MWO 5-2350-262-35-1

MODIFICATION WORK ORDER

MODIFICATION OF ARMORED COMBAT EARTHMOVER (ACE), M9

SYSTEM IMPROVEMENT PLAN (SIP) PHASE 4 BLOCK MODIFICATION

Figure 3-5. Right Side Installation

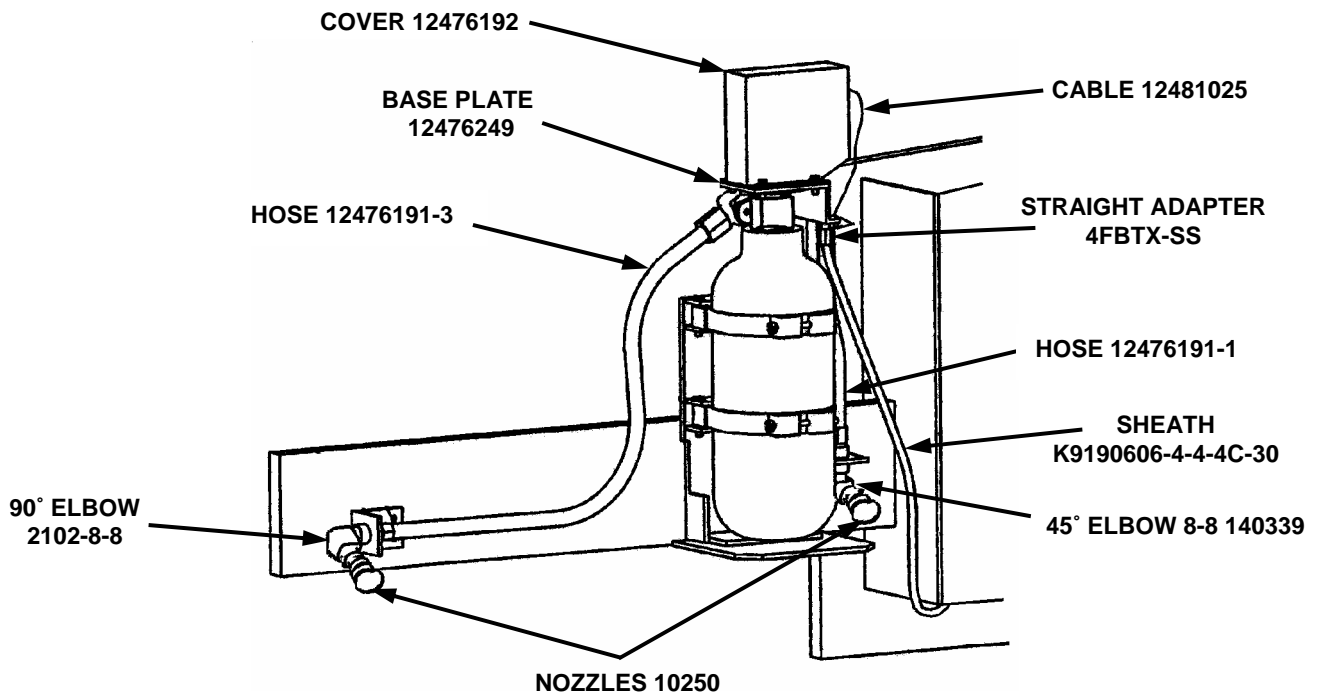
- f. Outside on right side of vehicle, wire rope free play measurement should not exceed two inches (changed from four inches to two inches).
- g. Refer to Figure 3-5 below to verify placement of hoses and elbows.
